INDIAN POINT NUCLEAR GENERATING UNIT NO. 2

AMENDMENT TO FACILITY OPERATING LICENSE

Amendment No. 36  
License No. DPR-26

ATTACHMENT TO LICENSE AMENDMENT NO. 36

Figure 6.2-1 Facility Management and Technical Support Organization

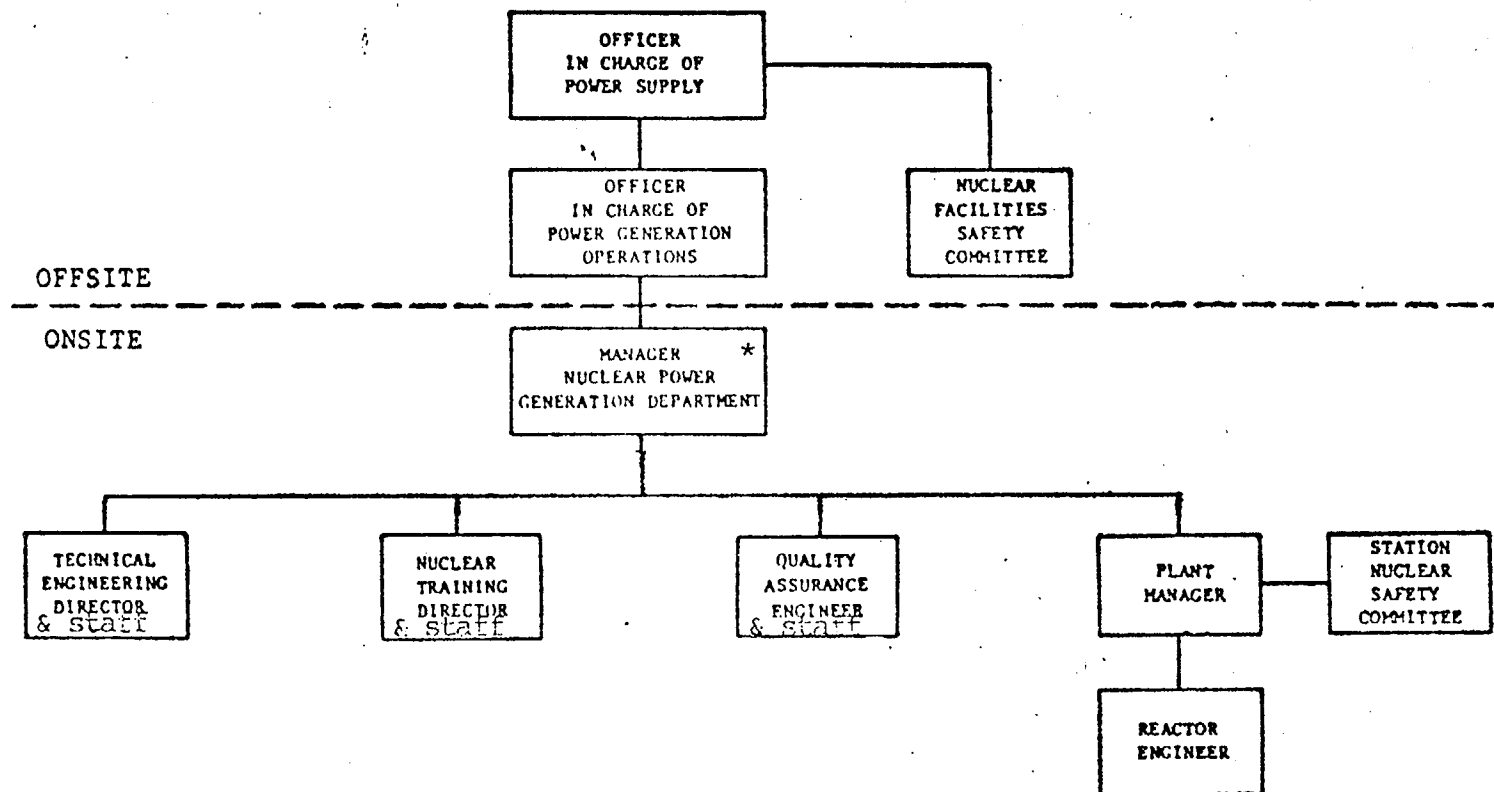
6.2-1

6.2-1

6.2.1 The organization for facility management and technical support shall be as shown on Figure 6.2-1.

Figure 6.2-1 Facility Management and Technical Support Organization

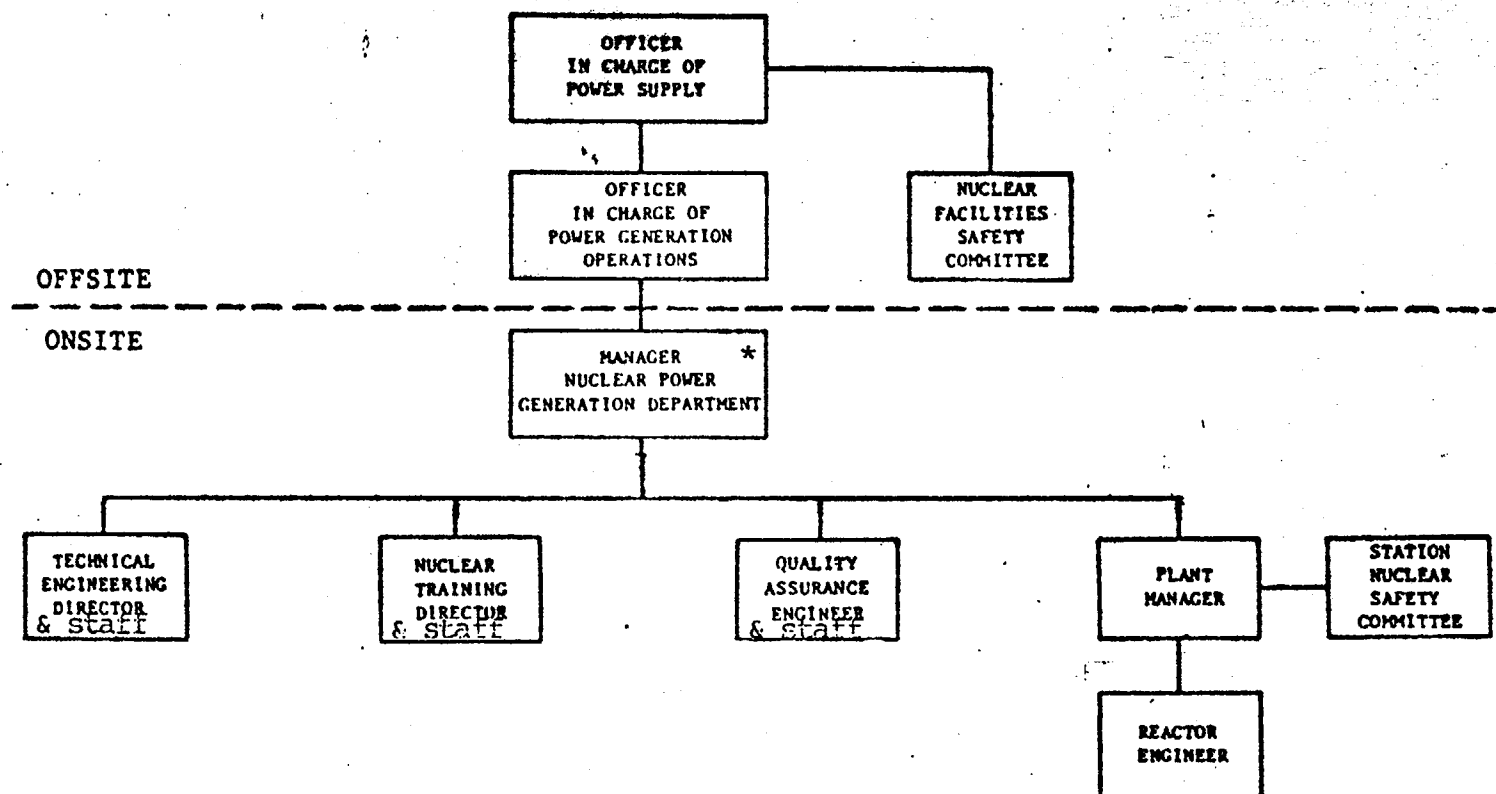
6.2.1 The organization for facility management and technical support shall be as shown on Figure 6.2-1.
